**Appeal Statement
Dealing with Access Matters**

**Proposed Single Dwelling
Land adjacent to Hawthorn Cottage, Malpas**

February 2020

- 2.1 I have been instructed by Mr Parry to prepare an Appeal Statement to address the access matters associated with the Appeal against the refusal of an application for a single dwelling at land adjacent to Hawthorn Cottage, Tallarn Green, Malpas.

Drawing No.
SCP/18316/F01

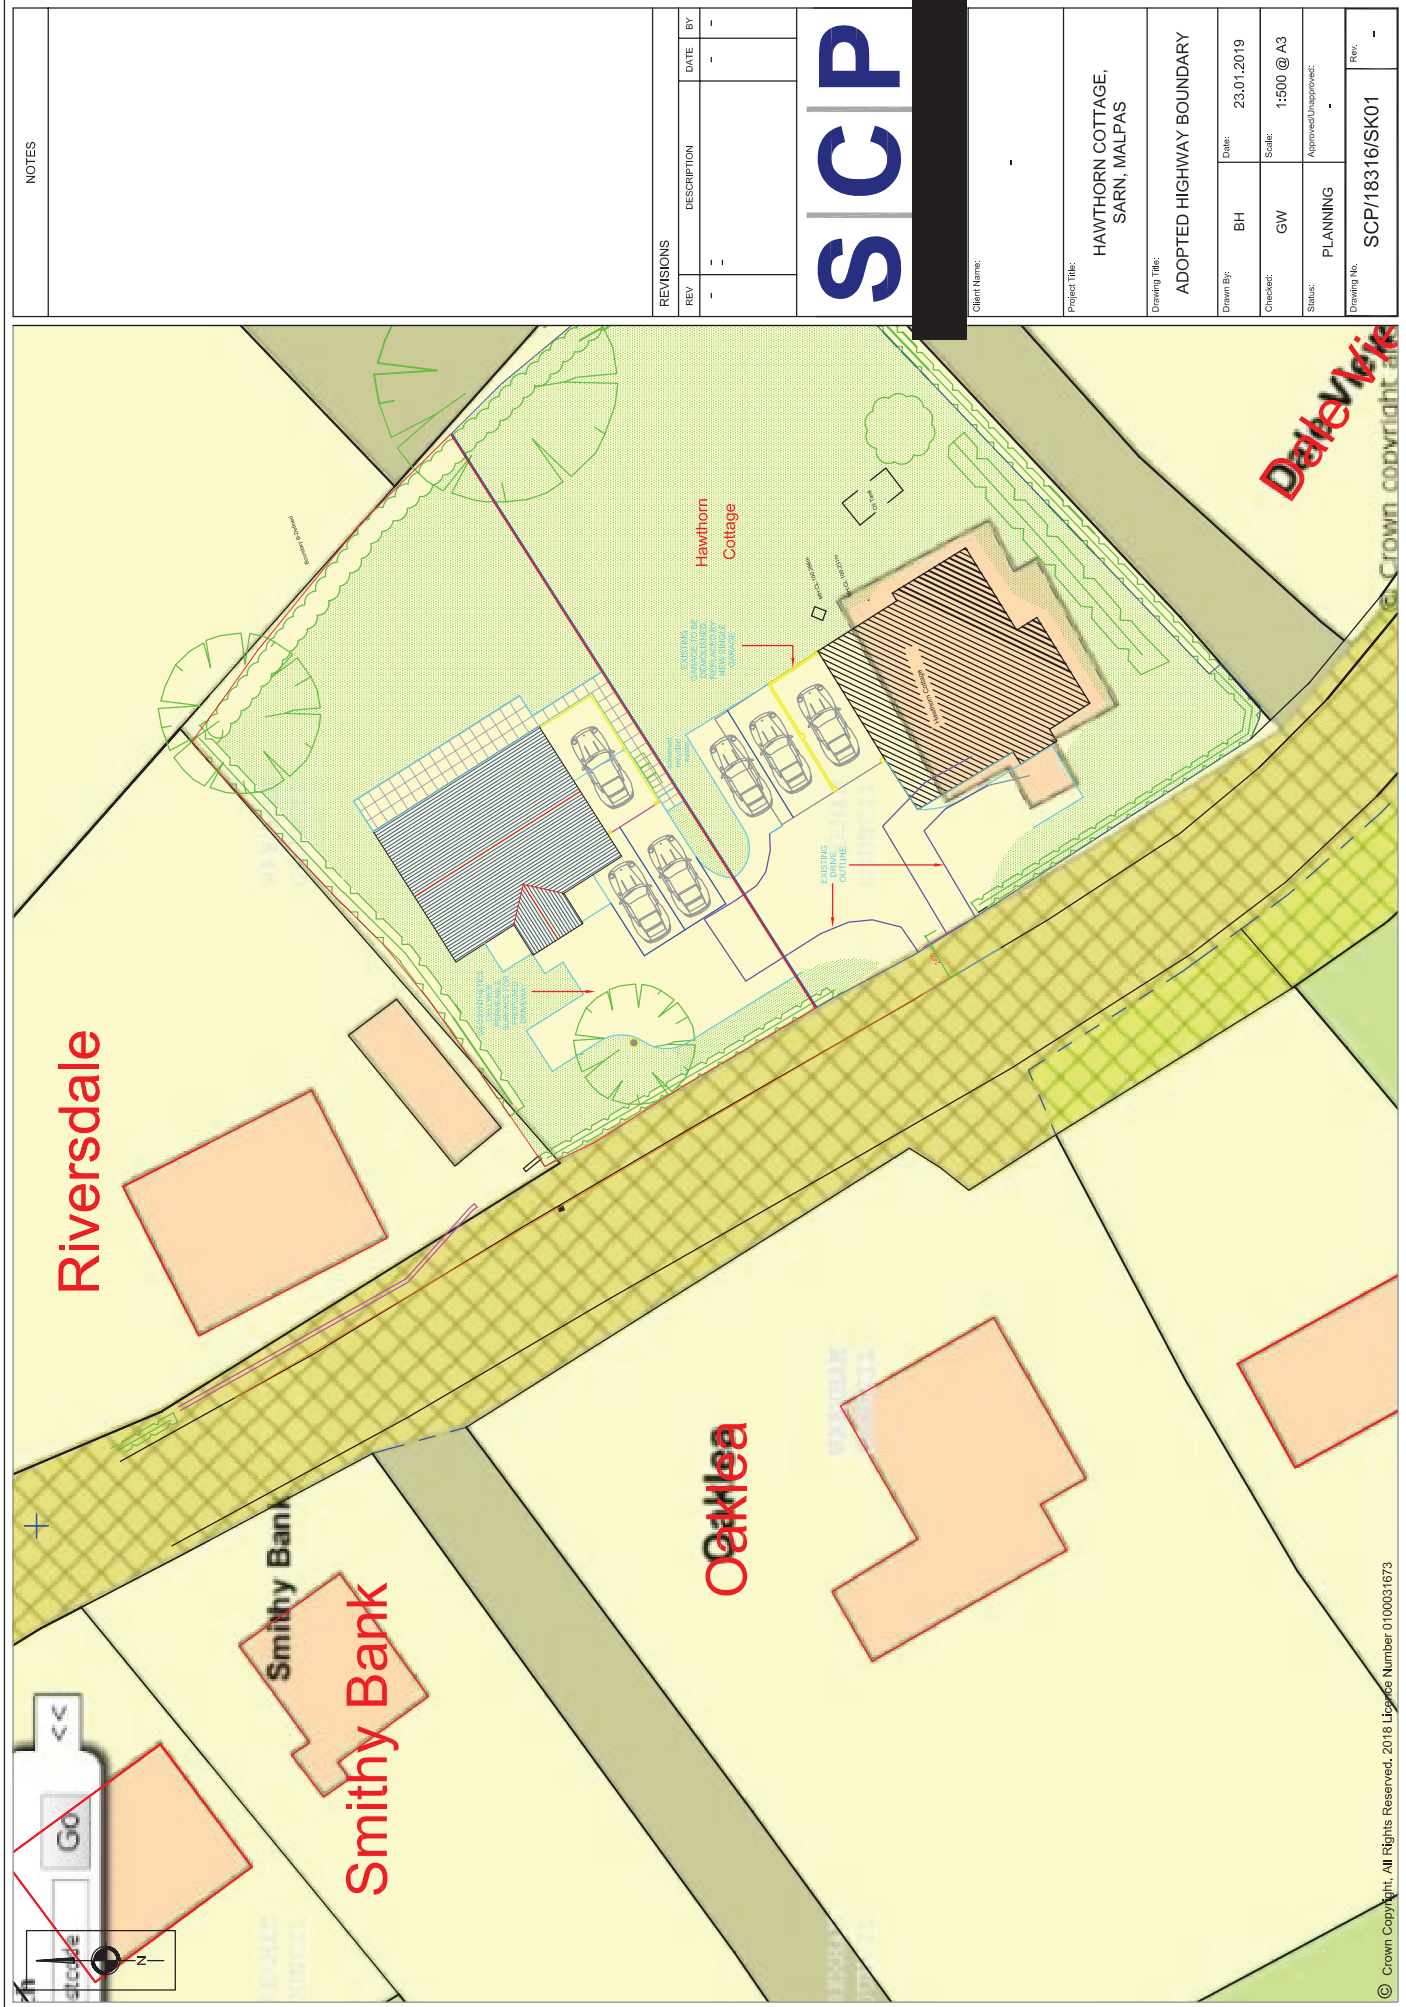
The achievable splays are considered to be inadequate to serve the proposed development and fall significantly short of the requirements of Manual for Streets. The required splays would appear to encroach over land under the control of Riversdale, Silverdale and Dale View. However, if the applicant could obtain appropriate agreements with the 3 no. neighboring landowners to provide these splays and demonstrate them on a revised layout plan then I would have no objections to the proposed development.

The access has been widened from 4.5m to 4.8m to allow two cars to pass each other. The revised access can be seen in Drawing SCP/18316/F01/Rev A. This has also been moved slightly to ensure more equal visibility splays in both directions.

The amended access results in a slight change in the achievable splays to give y-distances of 34m to the north and 35m to the south from a position of 2.4m x distance. According to the previous speed survey results and contained within Table 7.1 of Manual for Streets, a y distance of 38m to the north and 40m to the south should be acceptable. On this basis there is a shortfall of just 4m to the north and 5m to the south. These splays are what can be achieved within the highway boundary or control of the client when in reality the neighbours keep their hedges low to preserve their own visibility.

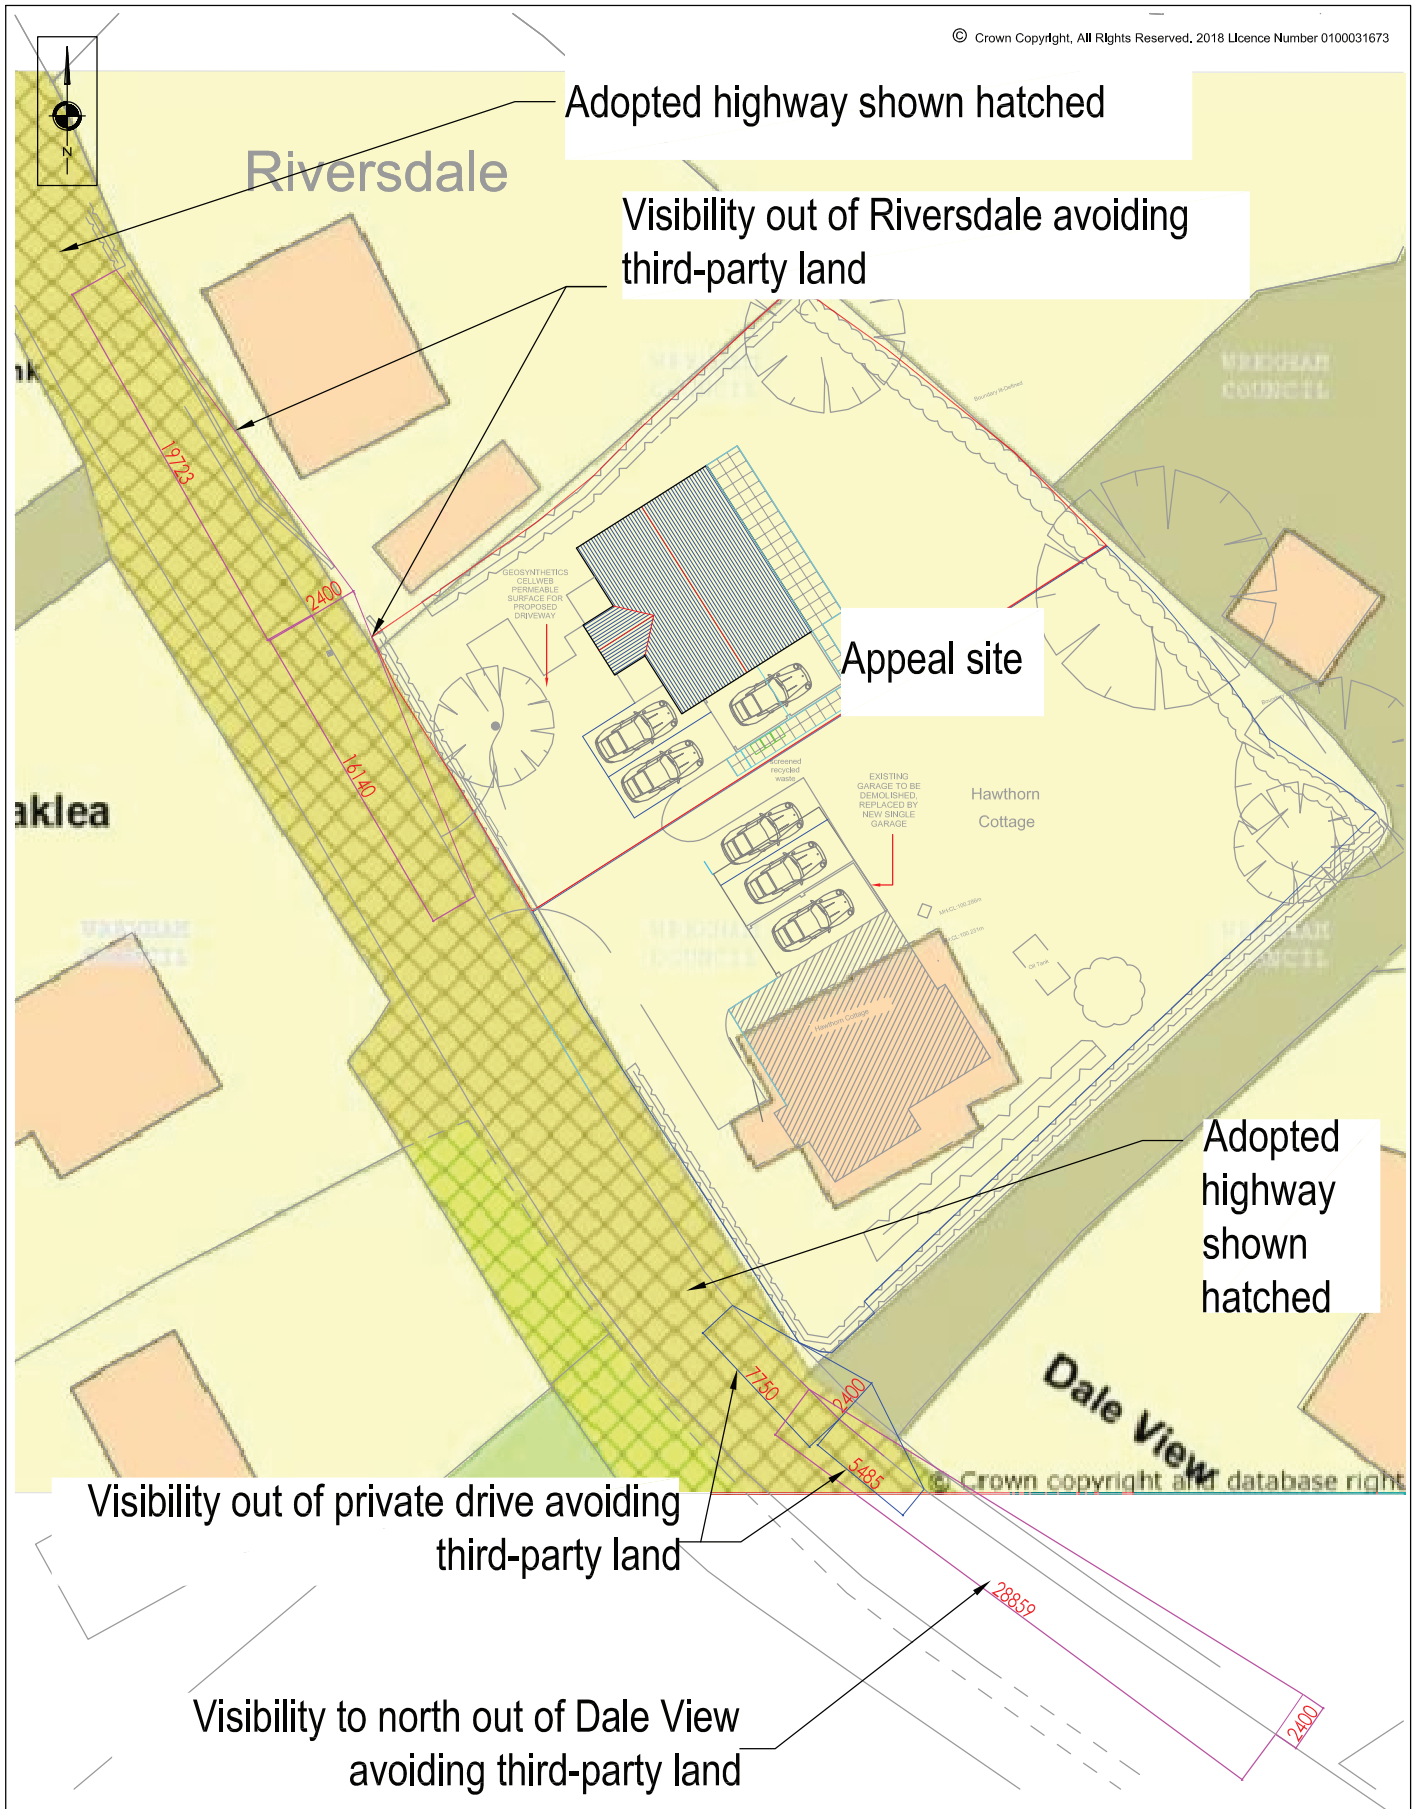
- 6.4 This situation occurs all along the same classified road. **Appendix 12** shows the visibility splays from neighbouring properties within their demise. Clearly many of these would rely on third party neighbouring land to achieve any visibility close to that set out in Manual for Streets. The visibility of neighbouring properties without relying on third party land varies from 28.5m to just 5.5m. However, there have not been any accidents associated with any of these access points.
